PROJECT COMPLETION REPORT

PROJECT NAME: **Timbalier Island Dune/Marsh Restoration Project**
CWPPRA/STATE PROJECT NO. **TE-40**

Report Date: **March 2005** **By:** **Shaw Coastal, Inc.**

SHEET 1 OF 6

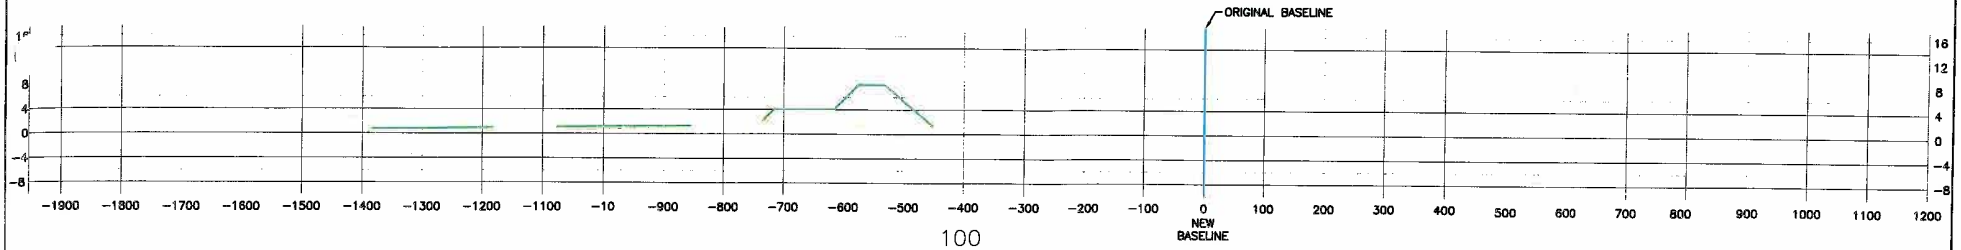
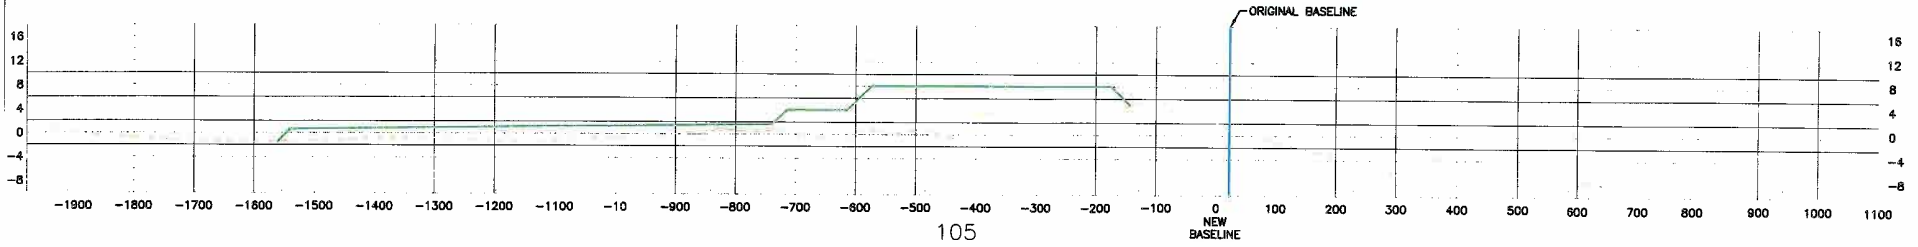
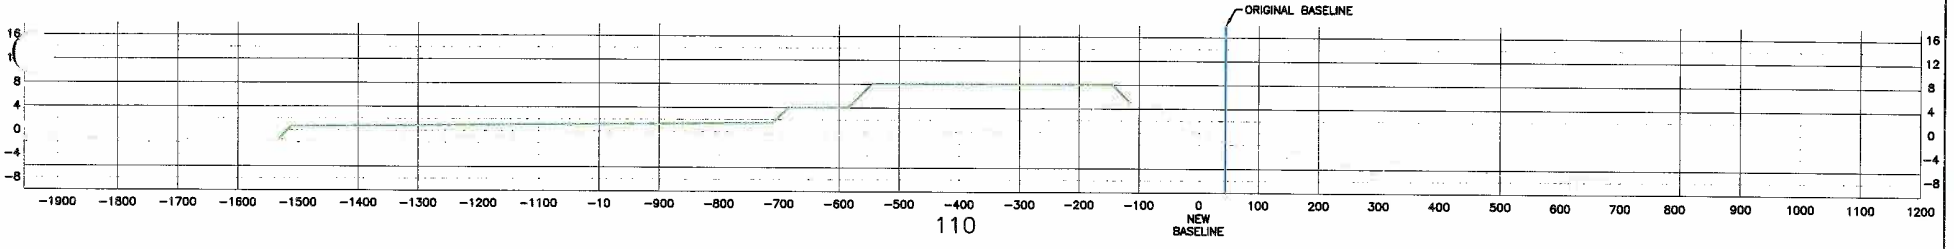
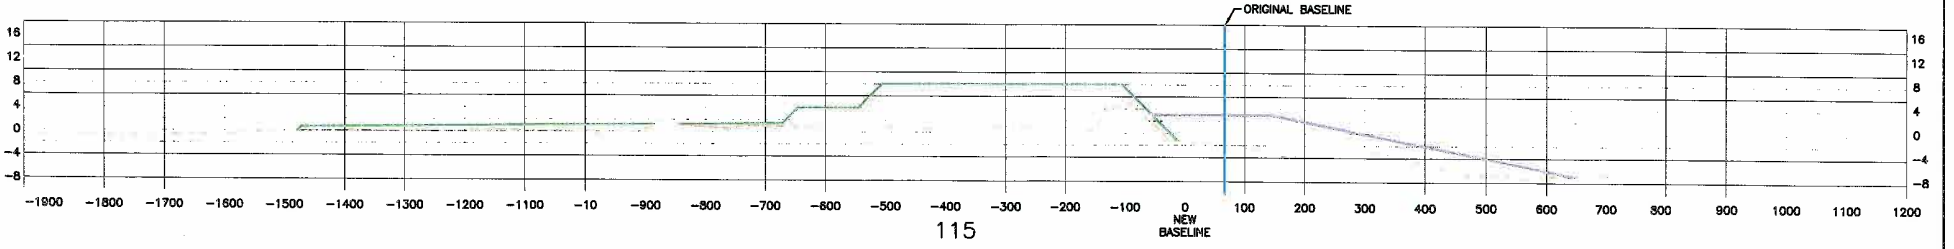
NOTE:
THE GULF SIDE BEACH FILL TEMPLATE AS DEPICTED ON SHEET 6 OF 23 OF THE CONSTRUCTION PLANS HAS BEEN REVISED AS FOLLOWS. THE BERM WIDTH HAS BEEN REDUCED FROM 300' TO ±200'. THE BEACH SLOPE HAS BEEN FLATTEN FROM 30:1 TO 50:1.

SHEET 2 OF 6

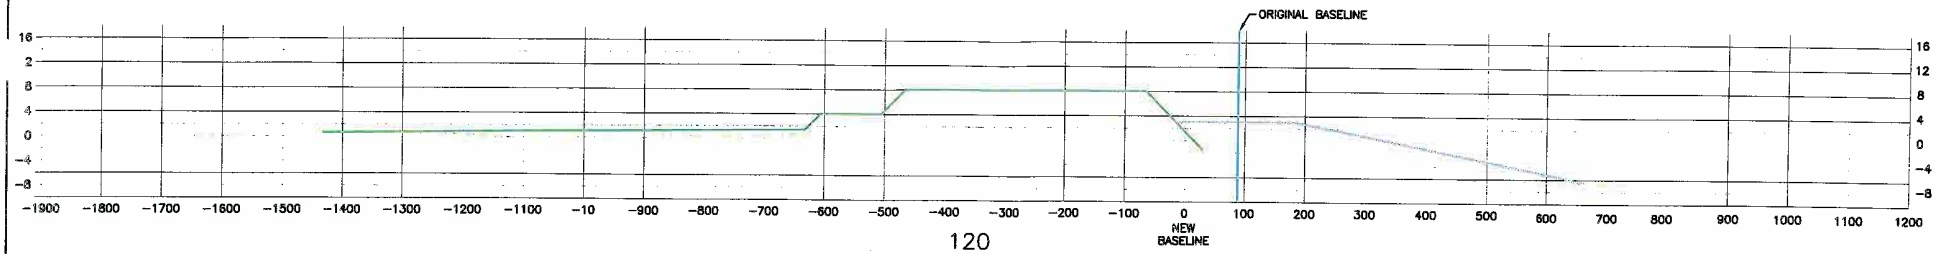
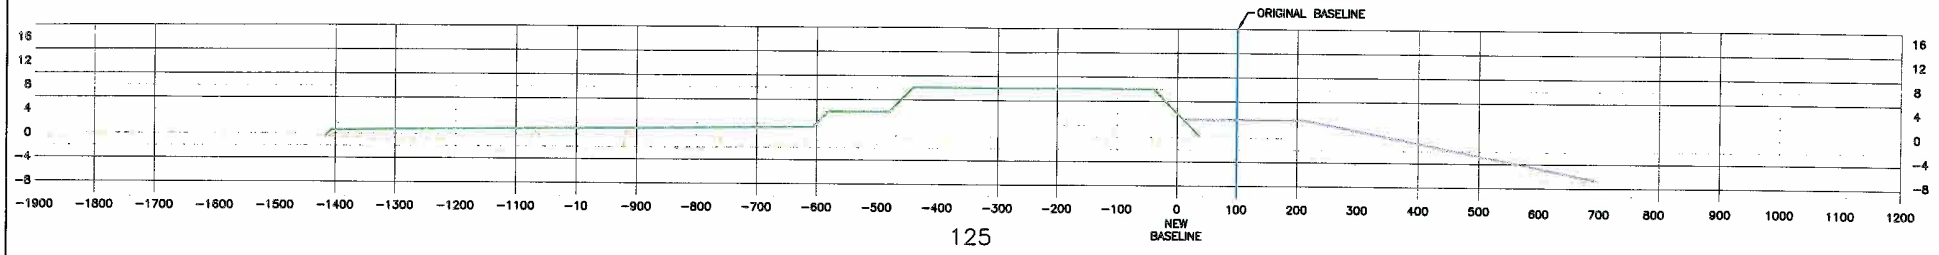
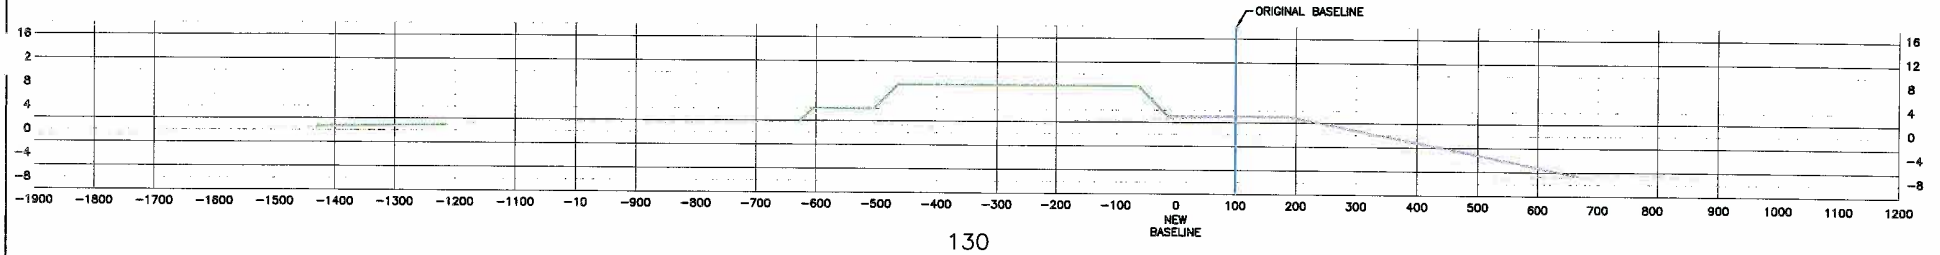
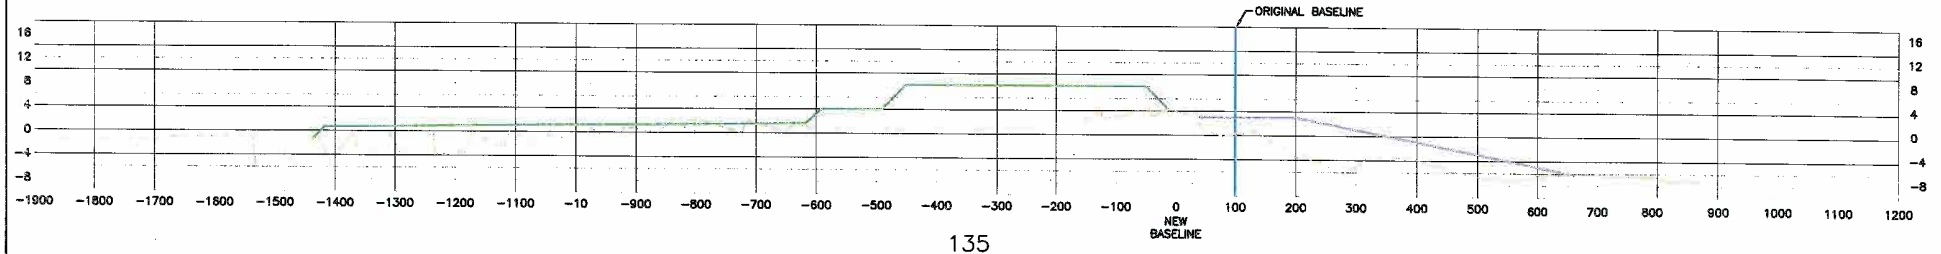
NOTE:
THE GULF SIDE BEACH FILL TEMPLATE AS DEPICTED ON SHEET 6 OF 23 OF THE CONSTRUCTION PLANS HAS BEEN REVISED AS FOLLOWS. THE BERM WIDTH HAS BEEN REDUCED FROM 300' TO ±200'. THE BEACH SLOPE HAS BEEN FLATTEN FROM 30:1 TO 50:1.

SHEET 3 OF 6

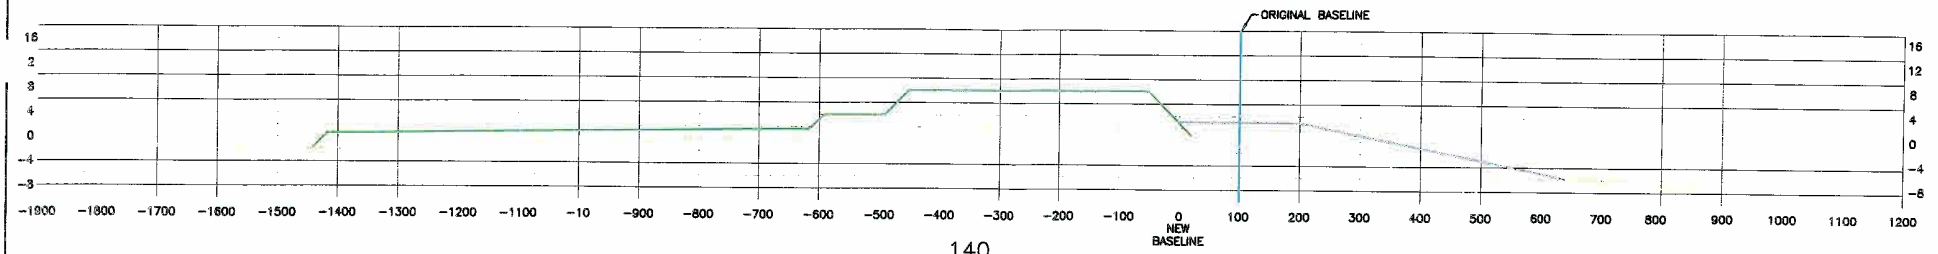
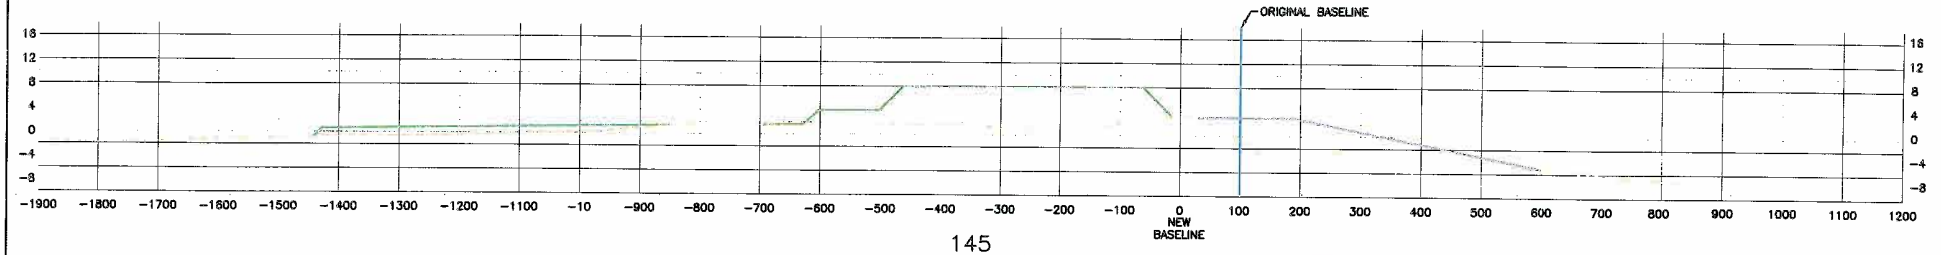
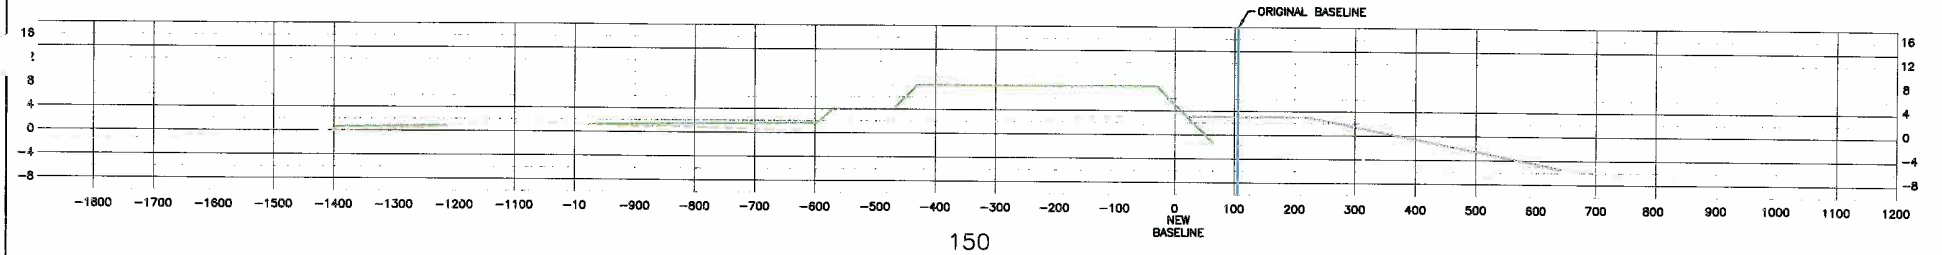
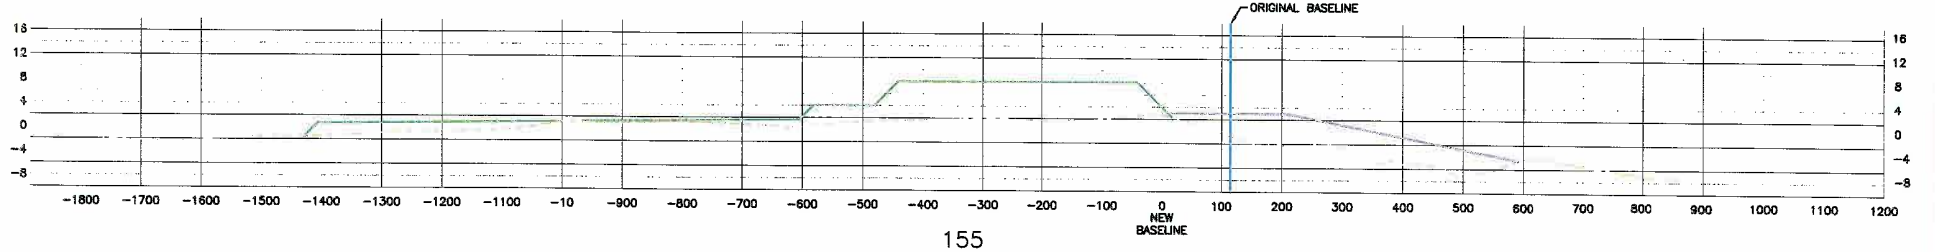
NOTE:
THE GULF SIDE BEACH FILL TEMPLATE AS DEPICTED ON SHEET 6 OF 23 OF THE CONSTRUCTION PLANS HAS BEEN REVISED AS FOLLOWS. THE BERM WIDTH HAS BEEN REDUCED FROM 300' TO ±200'. THE BEACH SLOPE HAS BEEN FLATTEN FROM 30:1 TO 50:1.

SHEET 4 OF 6

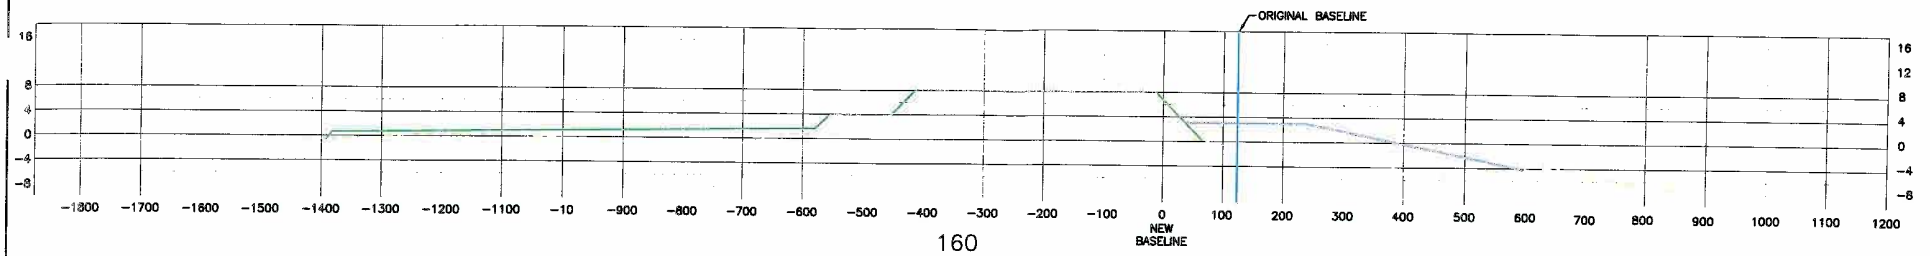
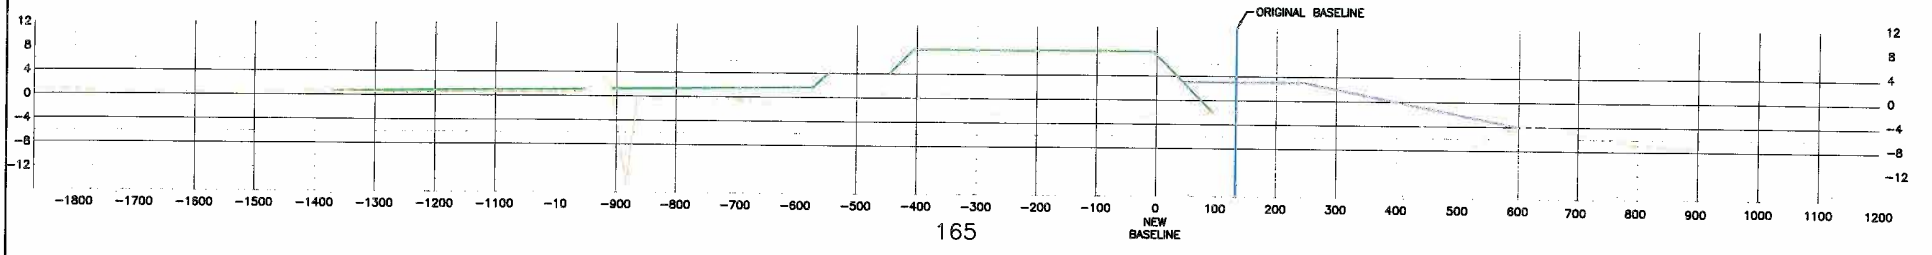
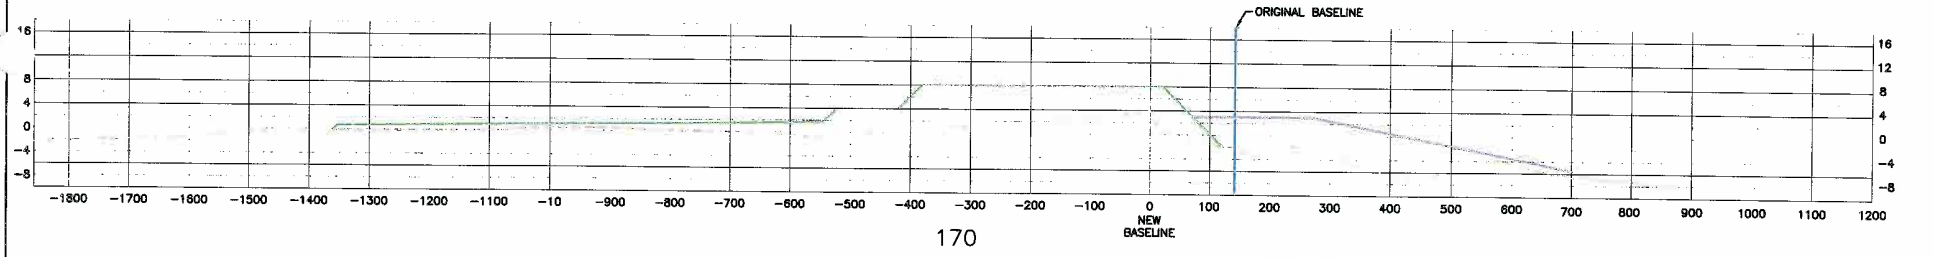
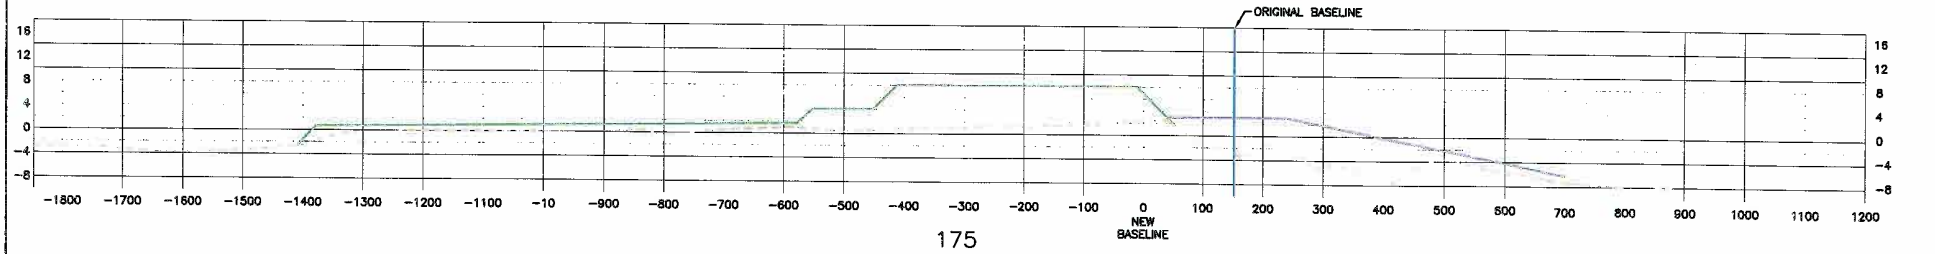
NOTE:
THE GULF SIDE BEACH FILL TEMPLATE AS DEPICTED ON SHEET 8 OF 23 OF THE CONSTRUCTION PLANS HAS BEEN REVISED AS FOLLOWS. THE BERM WIDTH HAS BEEN REDUCED FROM 300' TO ±200'. THE BEACH SLOPE HAS BEEN FLATTEN FROM 30:1 TO 50:1.

SHEET 5 OF 6

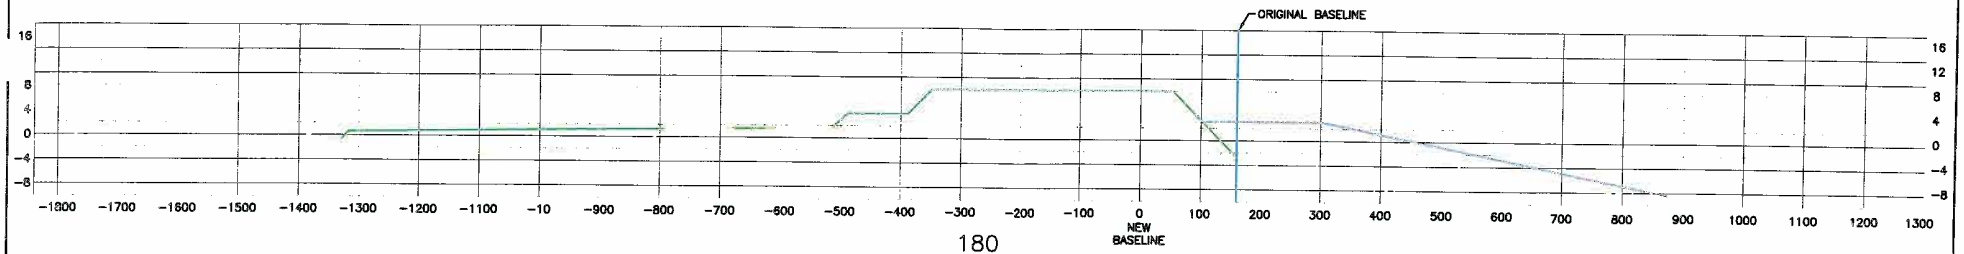
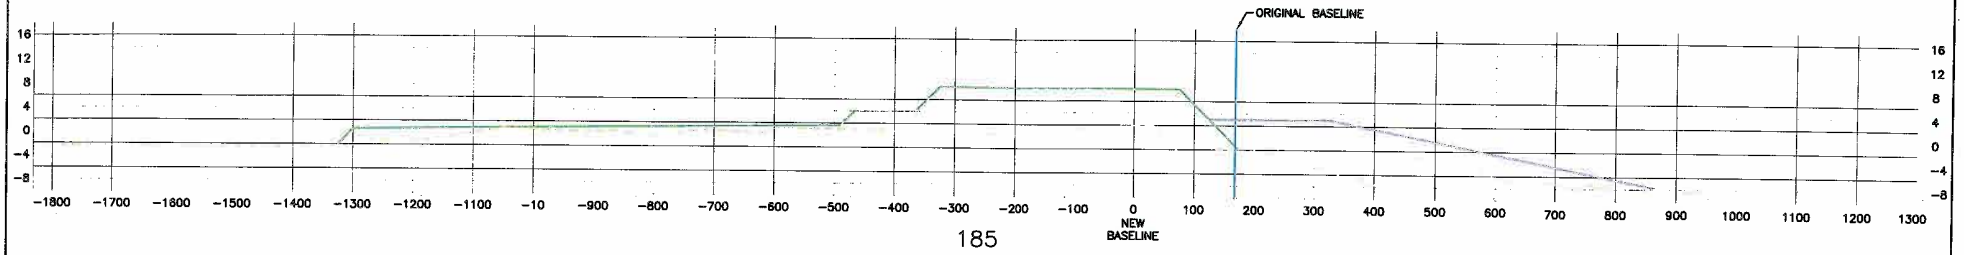
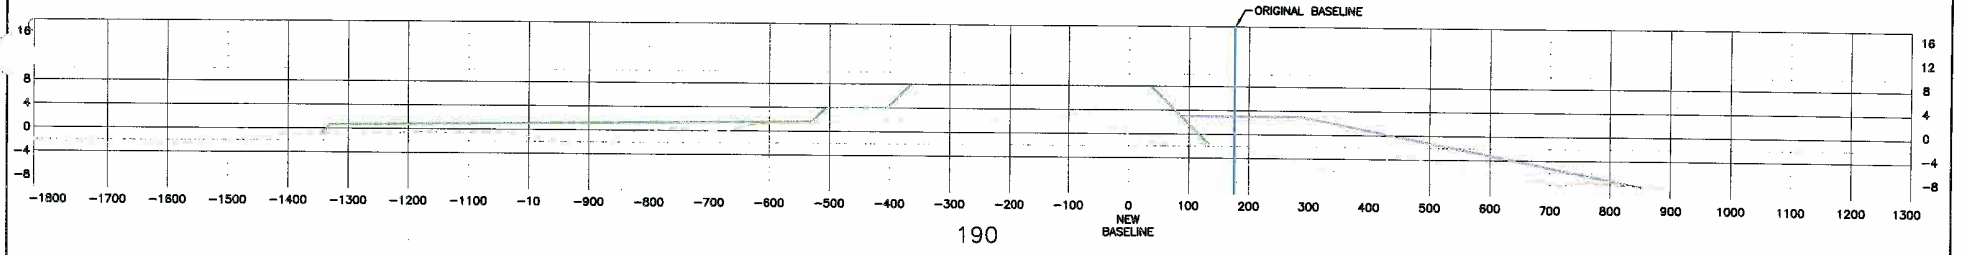
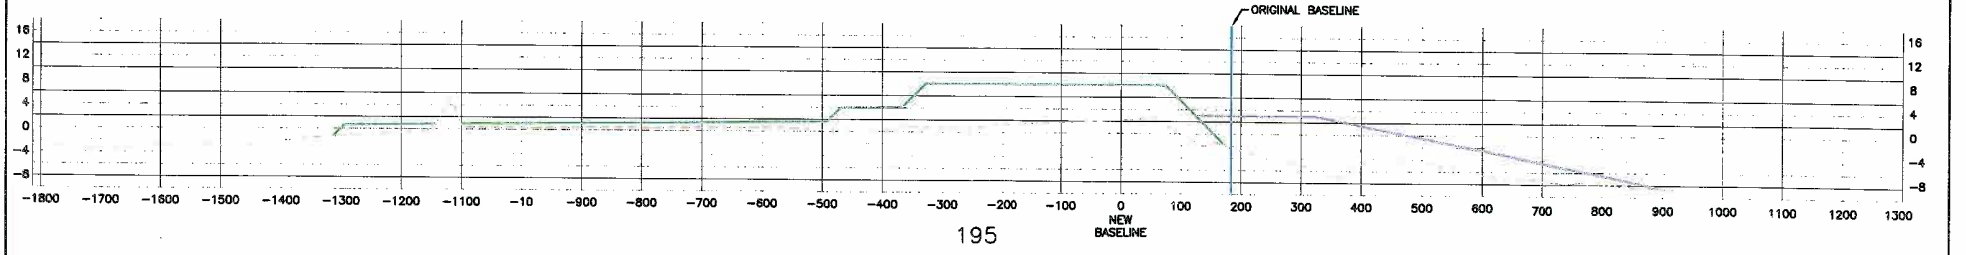
NOTE:
THE GULF SIDE BEACH FILL TEMPLATE AS DEPICTED ON SHEET 6 OF 23 OF THE CONSTRUCTION PLANS HAS BEEN REVISED AS FOLLOWS. THE BERM WIDTH HAS BEEN REDUCED FROM 300' TO ±200'. THE BEACH SLOPE HAS BEEN FLATTEN FROM 30:1 TO 50:1.

SHEET 6 OF 6

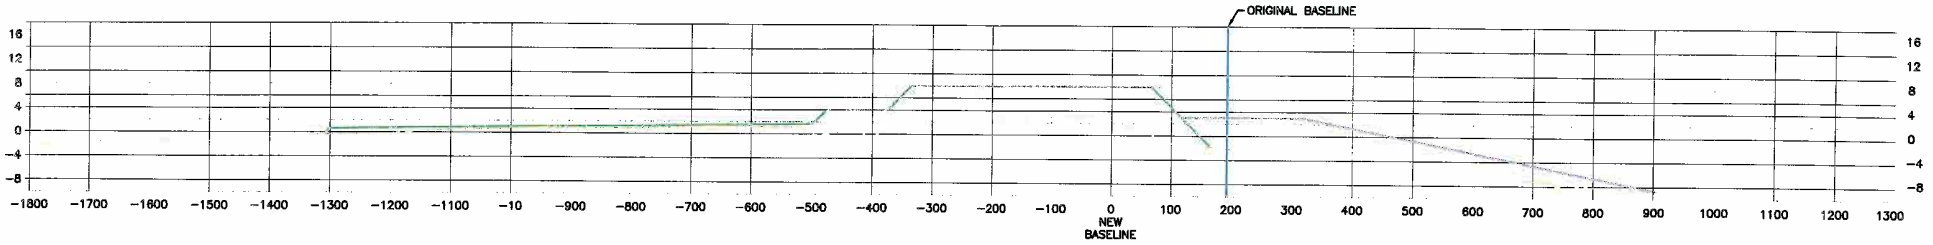
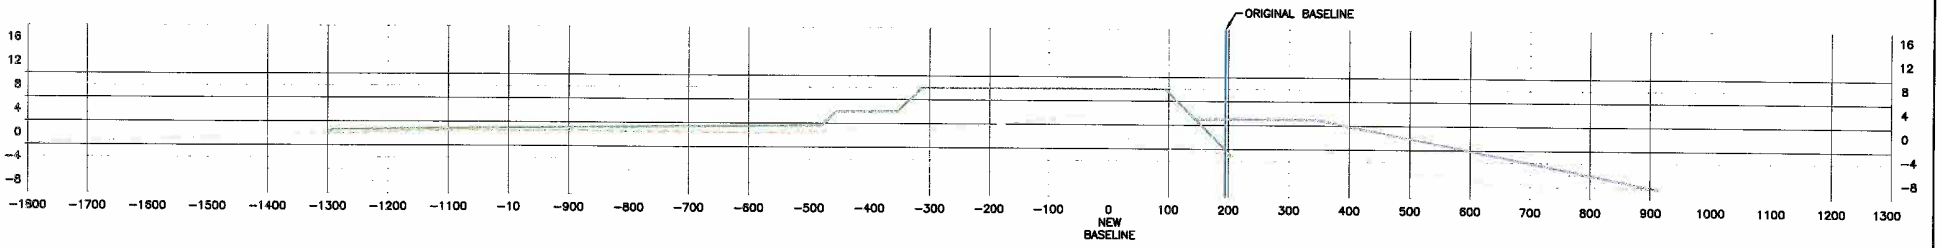
NOTE:
THE GULF SIDE BEACH FILL TEMPLATE AS DEPICTED ON SHEET 6 OF 23 OF THE CONSTRUCTION PLANS HAS BEEN REVISED AS FOLLOWS. THE BERM WIDTH HAS BEEN REDUCED FROM 300' TO ±200'. THE BEACH SLOPE HAS BEEN FLATTEN FROM 30:1 TO 50:1.
